Title: BE and CE IC Bus Driver Heater Resistor

Applies To: BE and CE Model School and Commercial Bus with Feature Code 48GHB or 48GHC

Part #	Description	Qty.
2511225C1	RESISTOR, 2 SPD, 12V, 184C	1

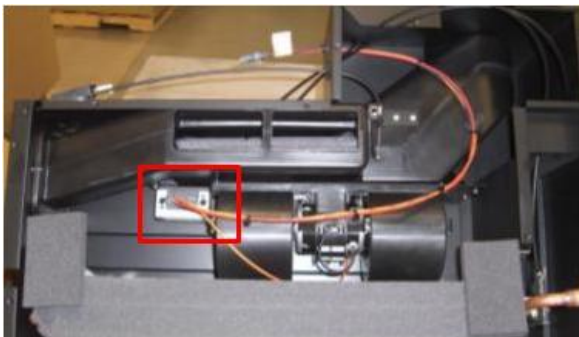
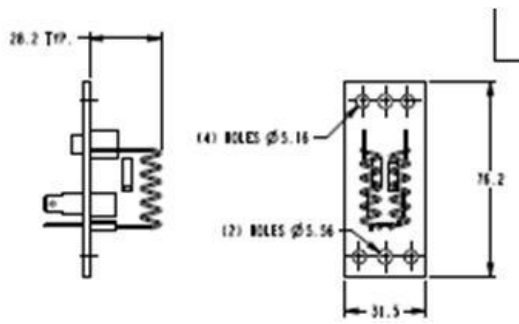
BE and CE driver heater experiencing early in life failure of the resistor. Failure of the resistor can result in loss of one or both fan speeds, most common is loss of low speed only. Failure is seen in single blower driver heater design, feature code 48GHB and 48GHC, produced 2011 through March 2013.

Resistor thermal cutout has been updated to eliminate failure. When replacing the resistor on units with the single blower design, feature code 48GHB or 48GHC, use new resistor, part number 2511225C1. Units built after March 2013 were produced with resistor 2511225C1.

Resistor 2511225C1 is to only be used on the single blower driver heater design. Installation of this resistor in any other heater application is not recommended or authorized.
